**Notification change of product marking of Power Inductors.**

**1. Reason of Change (Background)**

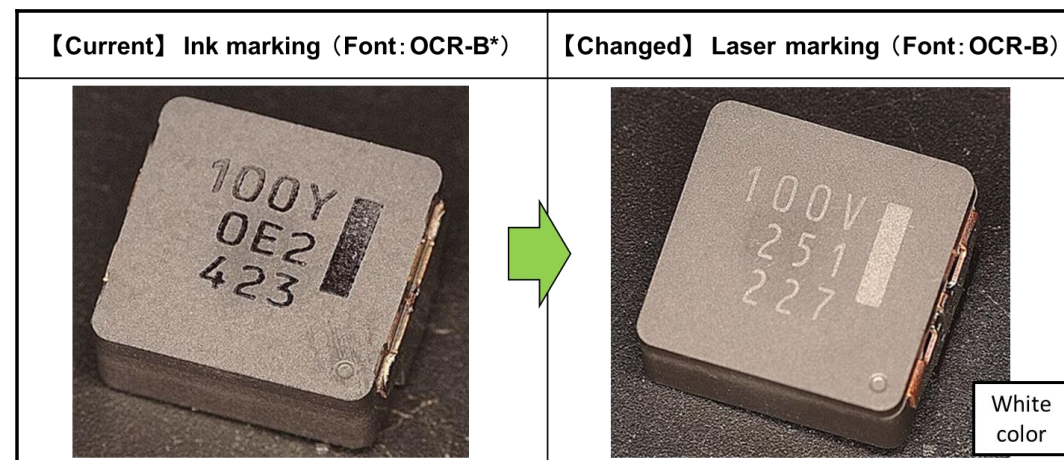
Change the marking method of the product display  
from "ink stamping method" to "laser printing  
method.

No change for the specification other than the surface appearance.  
Electrical characteristics, reliability, cautions, will be the same.
